FRONT ELEVATION 1
FOR LOT 149

ROSEWOOD 1
COMPLIANCE PACKAGE "A1"

SHEET TITLE: FRONT ELEVATION 1 FOR LOT 149

PROJECT NAME: RUSSEL GARDENS II

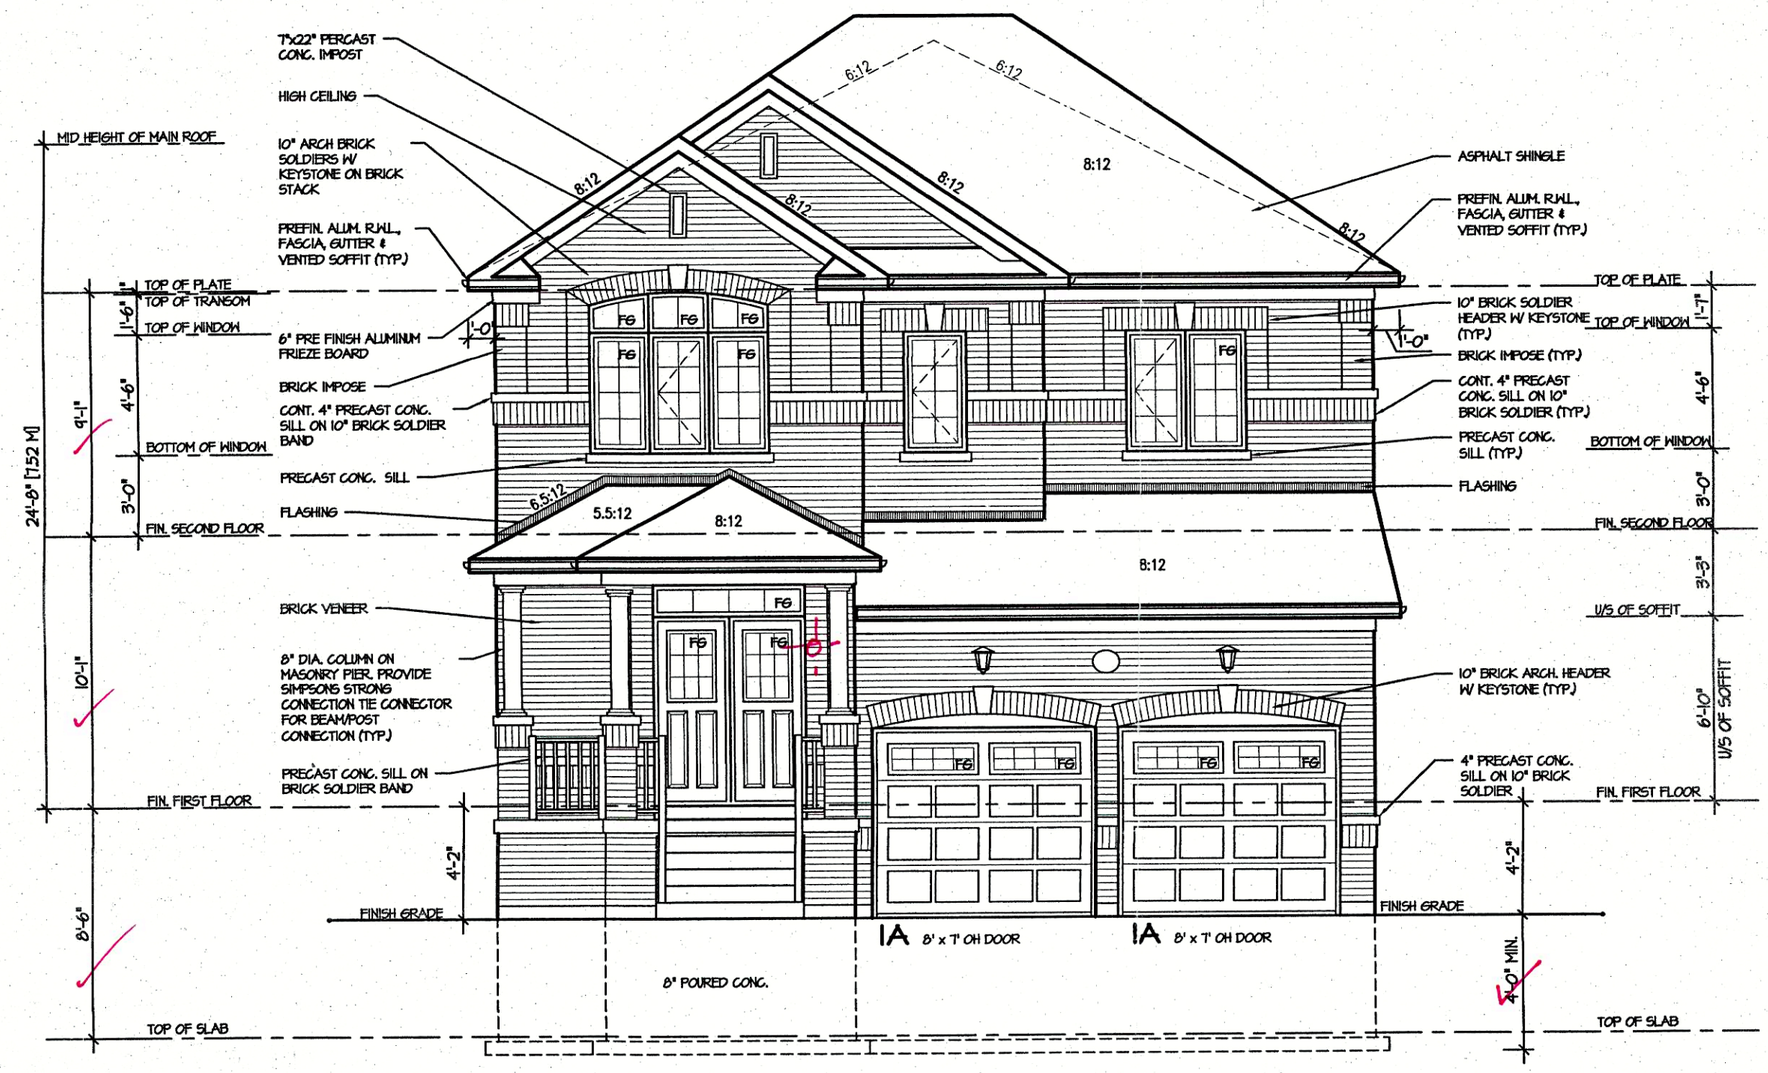
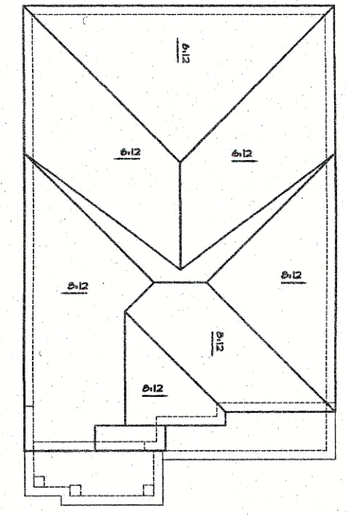
DROPPED FRONT GRADE CONDITION CHANGES:
- GARAGE ROOF DROPPED 1' 4"
- GARAGE ROOF SLOPE INCREASED TO 8:12
